SCC22 spec consistency and SCC11

Piers Dawe
IPtronics

FC-PI-5 comment IPtronics1

8GFC SCC22 specs (dB)

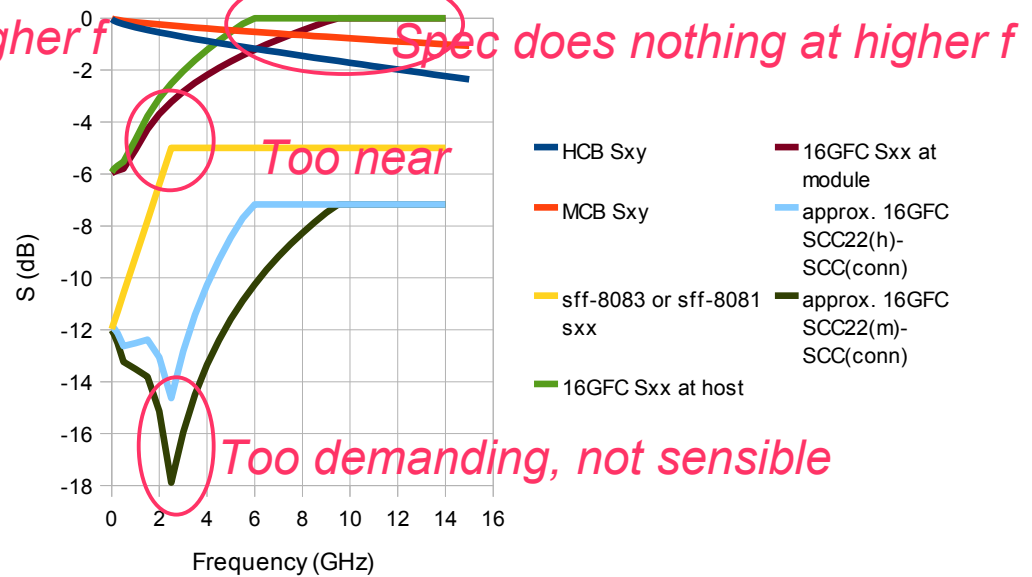
- Following on from D2.0 QLogic 3
- Presentation 10-163v0 shows that in order to achieve good differential return loss in SFP+ connectors it is advantageous to relax the common mode return loss
- The changes made in the last round, surprisingly, leave only a fraction of a dB at 3 GHz between a proposed connector SCCxx spec and the draft FC spec after de-embedding the compliance boards
- So the IC reflection would have to be very good (much better than -20 dB at 3 GHz)!

FC-PI-5 Rev 3.00 with proposed SFP+ connector SCCxx

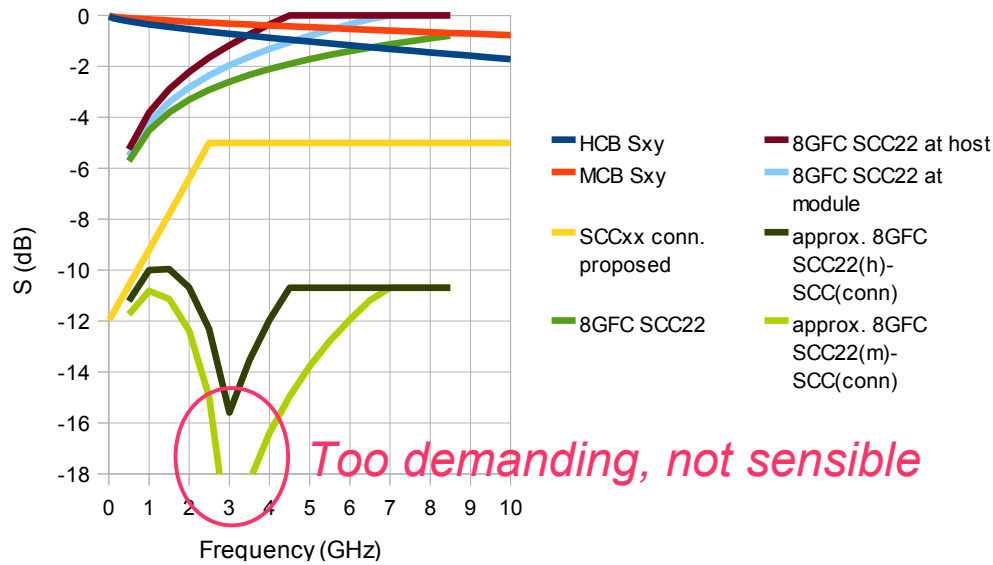
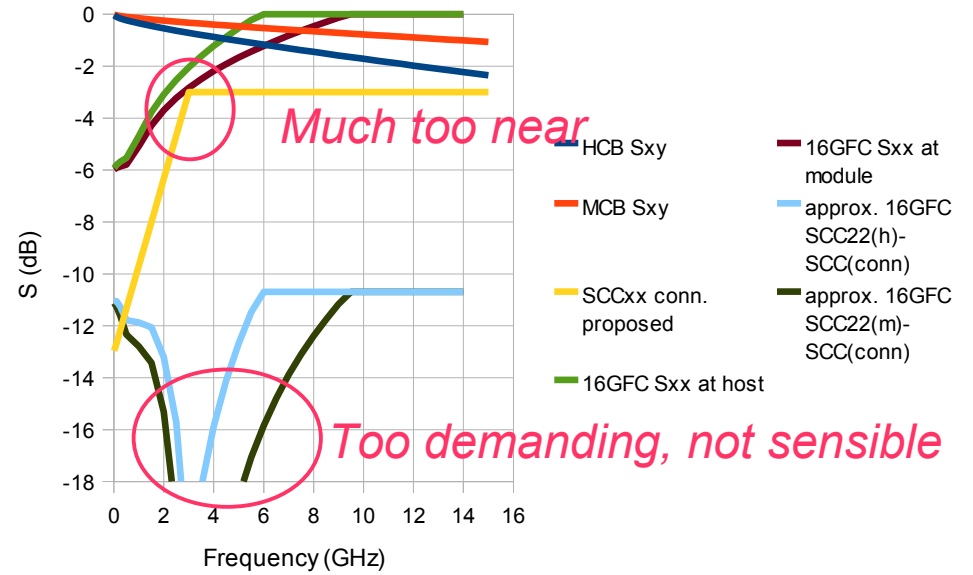
Expect next generation SFP+ connector will have worse SCCxx

Proposal per IPtronics1

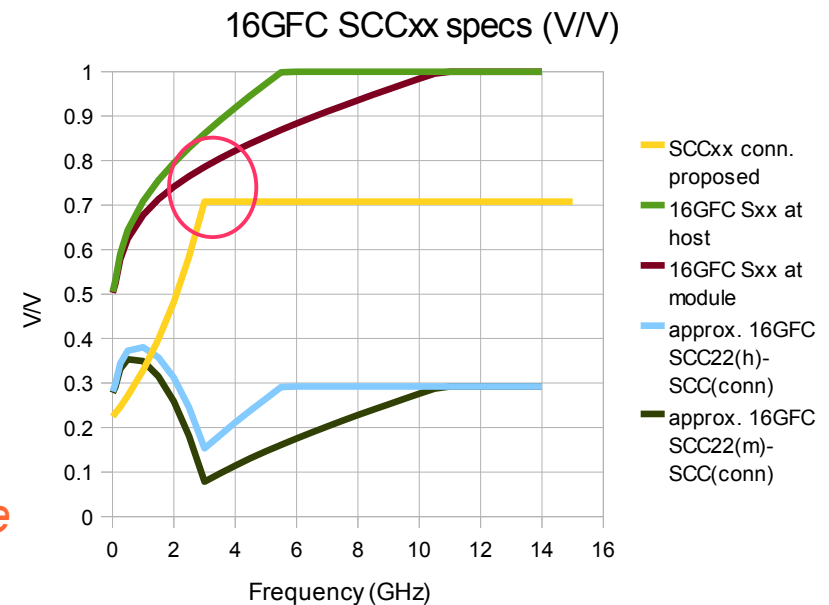
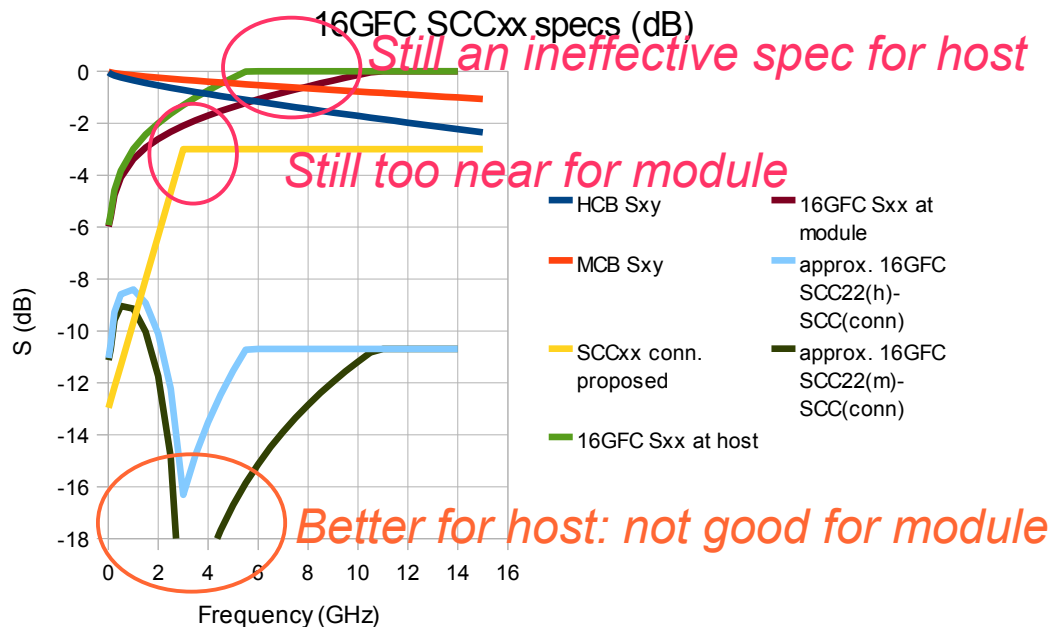
Reduce the parameter S (slope, dB/decade) from 4 to 2 for the 16GFC delta points SCC11, SCC22 (transmit and receive)

This will make the spec at 3 GHz more similar for 16GFC and 8GFC (with 16GFC still a little more demanding)

For the connector spec: try to avoid a sharp corner in the 3 GHz region

Improved proposal

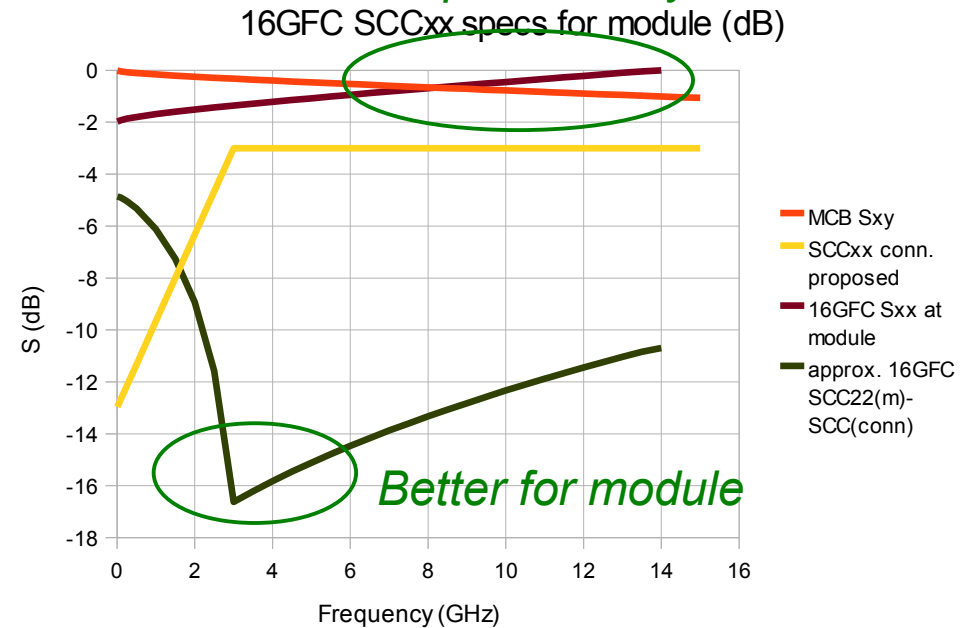
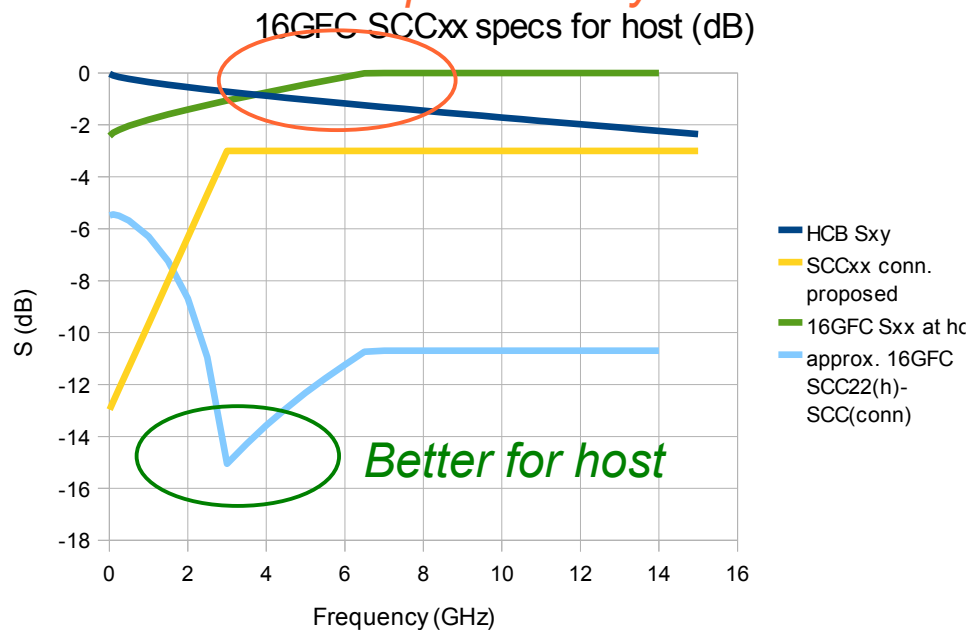
Reduce the parameter S (slope, dB/decade) from 4 to 0 and reduce N from -2 to -2.5 for the 16GFC host transmit points SCC22 (common-mode output return loss)

Reduce the parameter S (slope, dB/decade) from 4 to 0 for the 16GFC module receive points SCC22 (common-mode output return loss)

Suggest doing the same for 8GFC (plots in backup, slide 12)

Move SCC11 (common-mode input return loss) to 9.7.3 Electrical channel characteristics – see next slide

Newly discovered SCC11 issue 3/3: what's in the draft

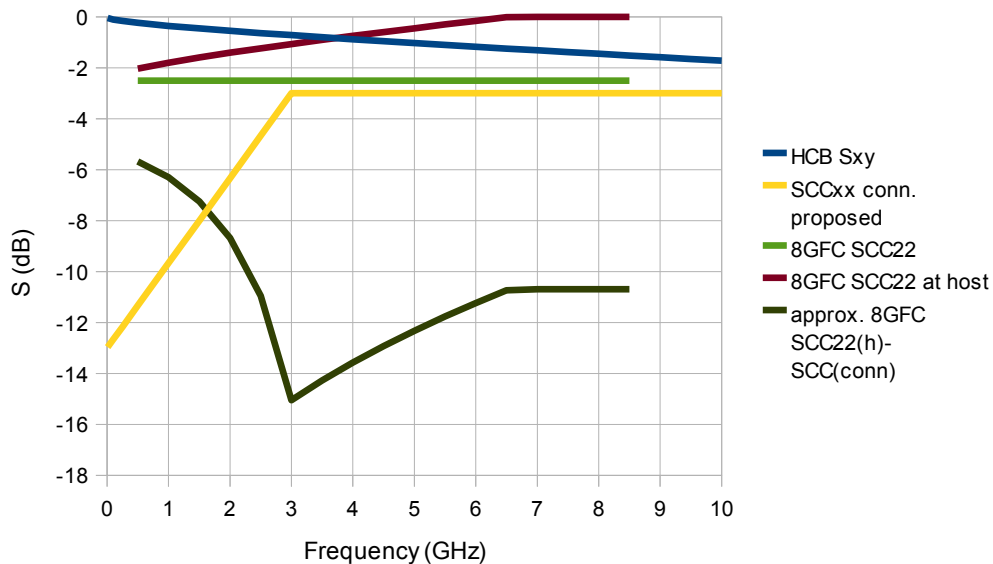
- 9.2.4 Return loss at the transmitter compliance points
 - Table 25 – S parameter at the Transmit Compliance Points
 - 400-DF-EL-S and 800-DF-Ex-S have SCC22 ("common-mode output return loss" in .3ba language) specs but not SCC11 ("common-mode input return loss"). This is like SFP+ and 802.3ba: the output is common-mode matched, which controls common-mode echoes, so the input does not need to be, allowing design flexibility e.g. choice of supply voltage

- 1600-DF-EL-S and 1600-DF-EA-S have SCC22 AND SCC11 specs:
 - Figure 31 – Sxx at beta T, epsilon T, and gamma T
 - and
 - Figure 32 – Sxx at delta T
 - show SCC22 but not SCC11

- Text of 9.2.4 mentions SCC22 but not SCC11
- 9.3.3 Return loss at the receive device compliance points
 - Table 28 – S parameter at the receive device compliance points

- Again, 400-DF-EL-S and 800-DF-Ex-S have SCC22 specs but not SCC11
 - Again, 1600-DF-EL-S and 1600-DF-EA-S have SCC22 AND SCC11 specs
 - Figure 36 – Sxx at the beta R, epsilon R, and gamma R

- and
 - Figure 37 – Sxx at delta R
 - show SCC22 but not SCC11
 - Text of 9.3.3 mentions SCC11 but not SCC22 in the first paragraph, and SCC22 but not SCC11. Later "Fibre Channel receiver devices shall meet the SCC22..."
